Following the submission of documents relating to the Planning Application 21/00953/FUL, comments, observations and requests for additional information have been received from the following consultees in respect of matters related to surface water drainage.

**SUPPLEMENTARY NOTES TO FRA AND
DESIGN STRATEGY REPORT
FELIX HOTEL, WHITEHOUSE LANE, CAMBRIDGE**

REF – 20 106

1. ANGLIAN WATER

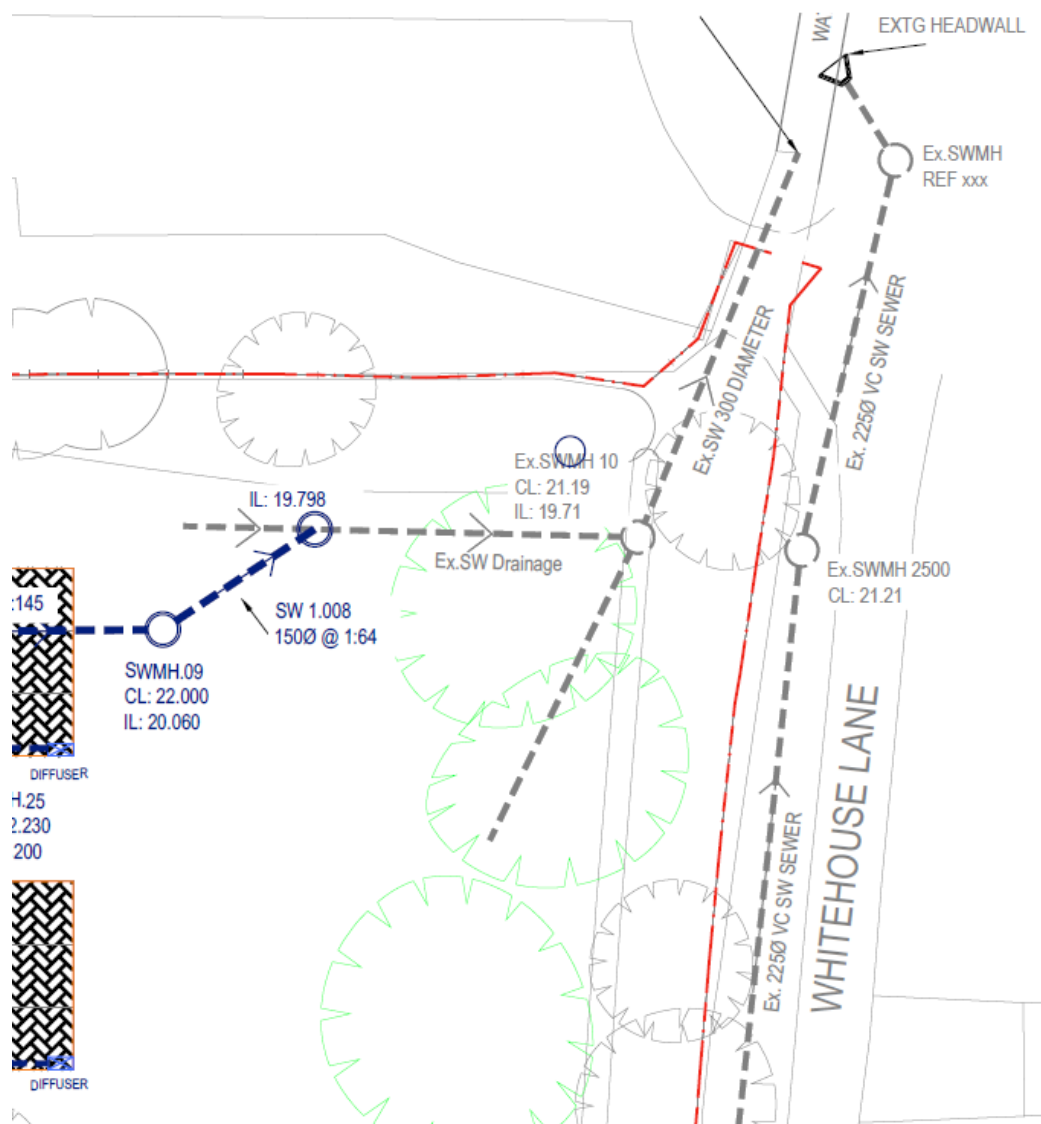
1. “It is noted that the surface water drainage strategy involves discharge to the sewers in Whitehouse Lane. These sewers are not owned by Anglian Water, we are therefore unable to agree/make comment on the suitability of a discharge to this location.”

Further investigation has been undertaken which shows that the surface water drainage does not connect to the public sewer in Whitehouse Lane as originally expected. It has been determined that the surface water discharges to the adjacent water course to the east of the site via a 300mm diameter pipe leaving ex SWMH 10 on the site boundary. This is shown on plan below with photographs in Appendix A.

The proposed strategy for discharge of surface water has been amended to be discharge to watercourse, subject to the necessary consents.

FLUVIAL FLOOD RISK

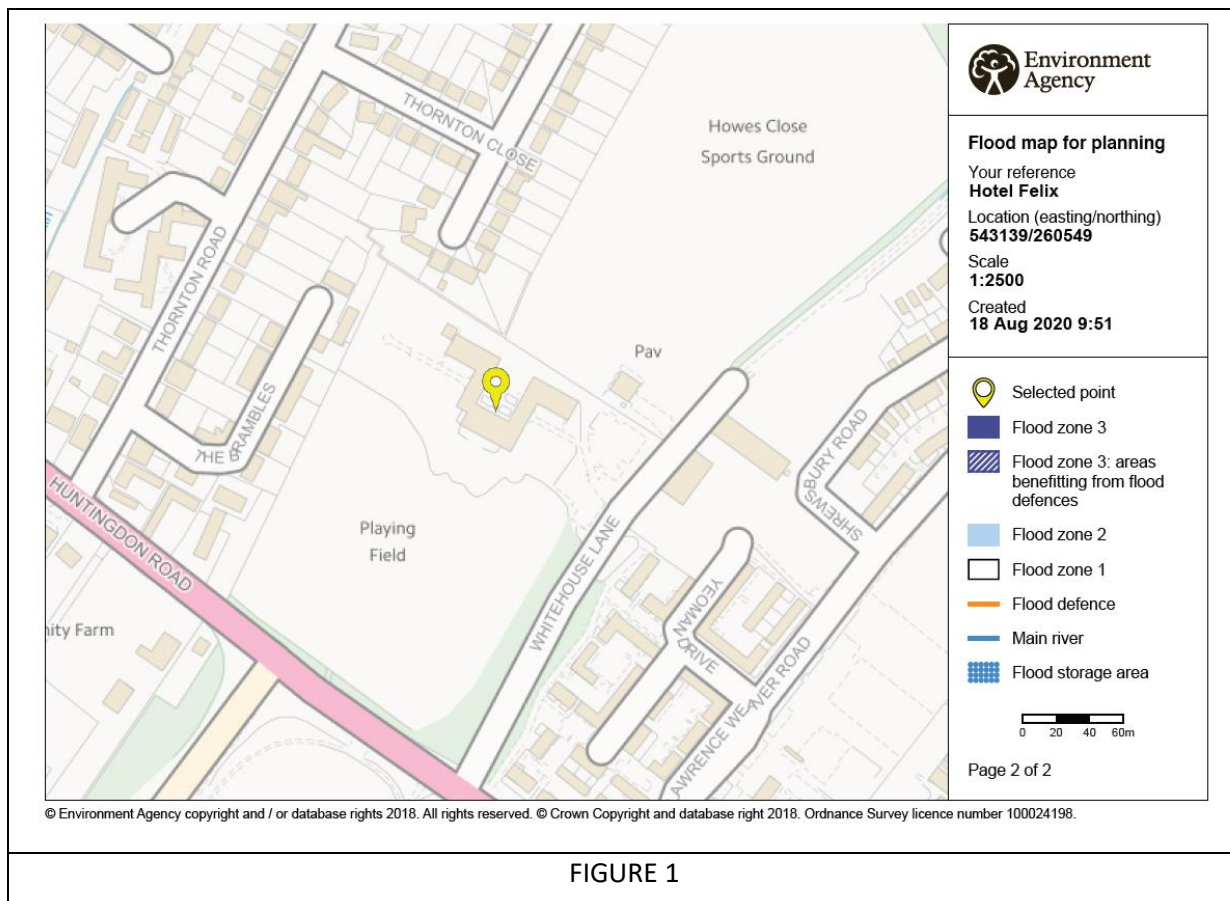
2. “The flood risk assessment should include an assessment of the flood risk from all sources of flooding. The flood risk should include assessment of: fluvial flood risk, mapped surface water, flood risk associated with potential overland flow from adjacent steeply sloping land, groundwater flood risk, flooding from surface water, foul sewers and summary of historic flooding records (if any)”

As noted in figure 1 below the site is not at risk from fluvial flooding.

Fig.1 The Downstream Defender® has internal components designed to maximize pollutant capture and minimize pollutant washout.

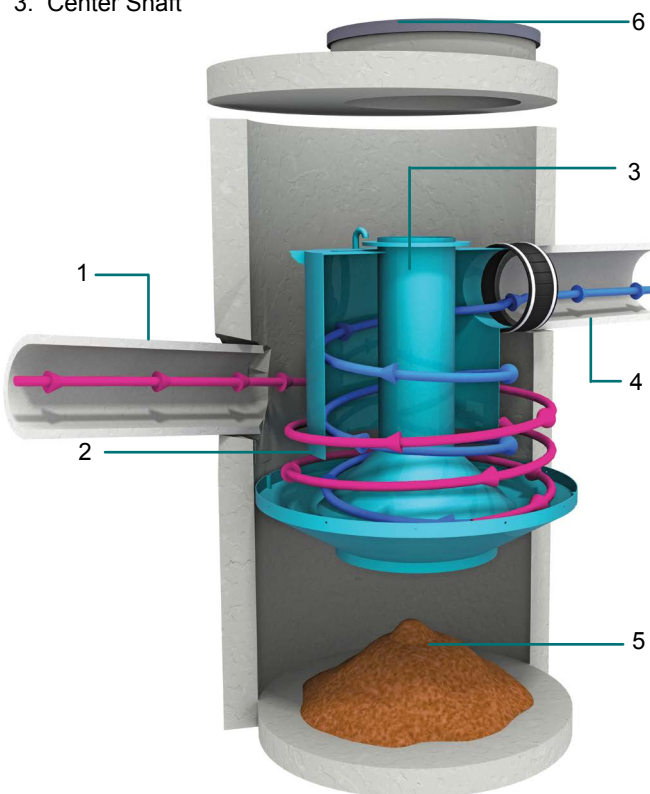
The system for treating water needs to accommodate for the highway water runoff on the access road. As it currently stands there is no treatment of the highways water runoff. This is not in line with the Pollution Hazard Indices within the CIRIA SuDS Manual (C753) Chapter 26. Additional surface water treatment is required on site to ensure all surface water runoff receives adequate treatment prior to discharging offsite. This could be through the use of open attenuation or permeable surfaces such as permeable paving over the access road. Until there is suitable treatment of surface water in line with the Pollution Hazard Indices we are unable to support this.

The proposals have been updated to include drainage to the access road and drained permeable paving to the car parking areas. Downstream Defenders (details provided in Appendix B) are to be included to capture sediment and pollution from the highway / access road prior to water entering the attenuation.
